Intel[®] Pentium[®] III Processor Specification Update

Release Date: June 2001

Order Number: 244453-031

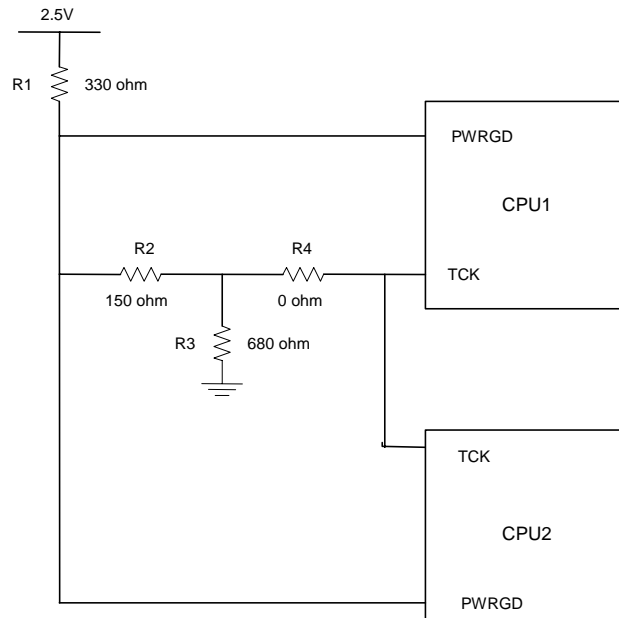
Problem: The internal control register bit responsible for operation of the Thermtrip circuit functionality may power up in a non-initialized state. As a result, THERMTRIP# may be incorrectly asserted during de-assertion of RESET# at nominal operating temperatures. When THERMTRIP# is asserted as a result of this erratum, the processor may shut down internally and stop execution but in few cases continue to execute.

Implication: This issue can lead to intermittent system power-on boot failures. The occurrence and repeatability of failures is system dependent, however all systems and processors are susceptible to failure. In addition, the processor may fail to stop execution during the event of a valid THERMTRIP# assertion resulting in the potential for permanent processor damage.

Workaround: To prevent the risk of power-on boot failures or catastrophic thermal failures, a platform workaround is required. The system must provide a rising edge on the TCK signal during the power-on sequence that meets all of the following requirements:

- Rising edge occurs after Vcc_core is valid and stable
- Rising edge occurs before or at the de-assertion of RESET#
- Rising edge occurs after all Vref input signals are at valid voltage levels
- TCK input meets the Vih min and max spec as mentioned in EMTS
